NABI 60BRT: Cooling System Updates (4B)

Issue: Air in the cooling system.

Reason/ cause: Cooling system was updated to enhance de-aeration.

Work instruction number L3/FSV-126
L4/QUA-003

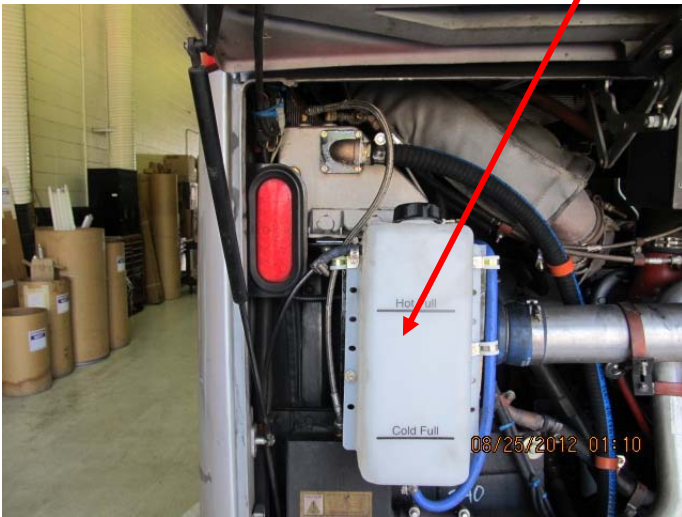
4. Replace existing surge tank fill cap with new adapter plate assembly, which includes 90 elbow and 1" hose barb. Seal treads with thread sealant.

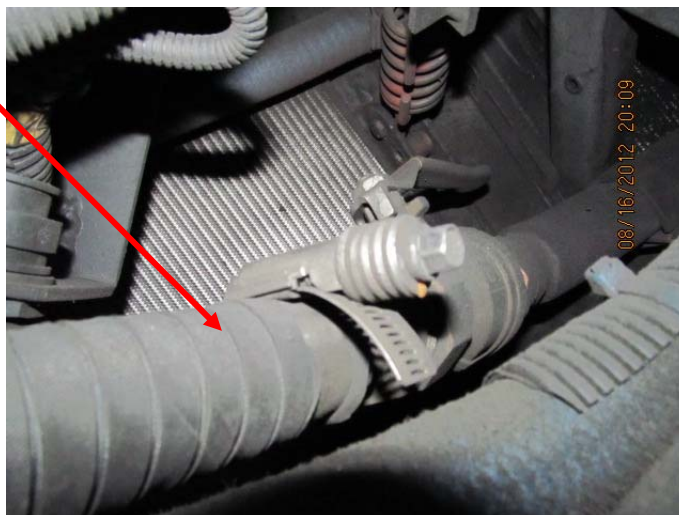
- Route 10' of EZ Form hose from adapter plate on surge tank and secure it with P-clamps as pictures show below.
